Public Hearing Staff Analysis
CZ-4-2024
Sam's Xpress

Zoning
Existing: Planned Business (PB)
Proposed: Highway Commercial

Proposed Use
New automated car wash with vacuums and fuel

SITE PLAN

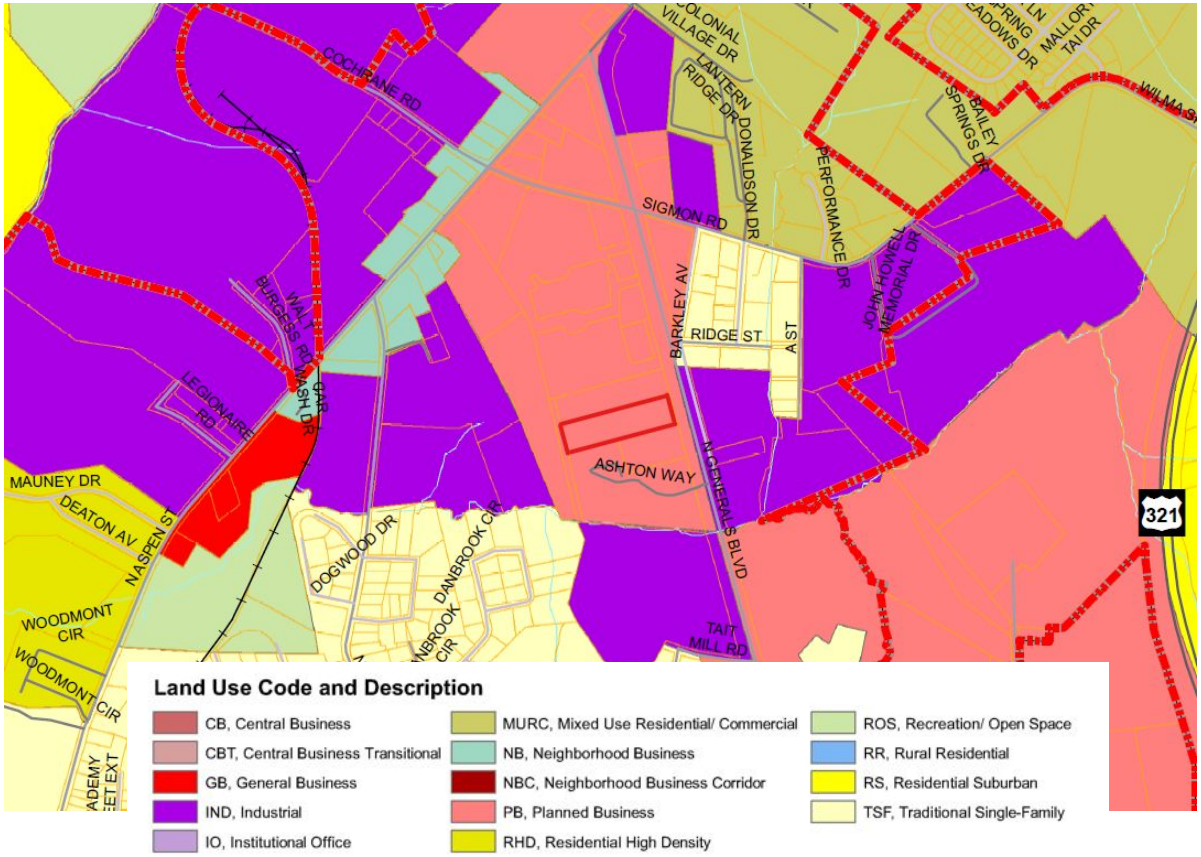
1. Maximum 70% impervious surface area. Will need the actual calculations on the amount of impervious area.
2. A complete set of final civil drawings meeting all UDO requirements must be submitted and approved by all departments before the site plan can be approved.
3. Development on the site is to be consistent with the above site plan and architectural renderings.
4. Building plans must be submitted and approved by Lincoln County Inspections prior to development.
5. Need to obtain demo permits from City Zoning and Lincoln County Building Inspections
6. In the area to the rear of the property, the City would like to see as many trees saved as possible and show on the construction plans the trees that would remain.

1. Required to meet Appendix D of the Fire Code
2. Need to submit a demolition safety plan in accordance with chapter 33 of the North Carolina State Fire Code

1. A sidewalk, meeting the City of Lincolnton requirements, must be installed along the entire frontage of N. Generals Blvd and connect to the existing sidewalk to the south.

1. No Driveway Permit needed
2. An encroachment agreement will be needed if the required sidewalk is placed on the NCDOT Right of way.

1. The construction work should not disturb the existing transformer and primary lines.
2. If a larger transformer or a different secondary voltage is needed, the customer will be responsible for the cost of the replacement and any new transformer. This also applies to relocating the existing primary lines.
3. The City Electrical Department needs to evaluate a copy of the load calculated by the electrical engineer. City can verify the transformer's KVA and secondary voltage upon request.
4. The customer is responsible for installing properly sized wire in properly sized conduit, meeting NEC requirements, to our transformer.
5. No grading that would reduce the existing clearance from final grade to the depth of our existing primary wire is allowed.

Water:
   - There is an existing 2-inch water line supplying current meters. If a 2-inch meter is needed, it cannot be connected to this line as it will cause pressure issues at the County Office and Murphy's.
   - Alternatively, there is a 12-inch ductile water main across N General Blvd that can be connected to. However, DOT encroachment will be required, and there will be a need to bore N Generals Blvd.
   - There is also an 8-inch water main along the Tractor Supply building that can be connected to, but this will require crossing the parking lot.

Sewer:
   - Sewer is located in front of N. Generals Blvd and will require a grease/grit removal tank.

1. This project will require an EC plan to be submitted for review and approval to Lincoln County prior to any grading.
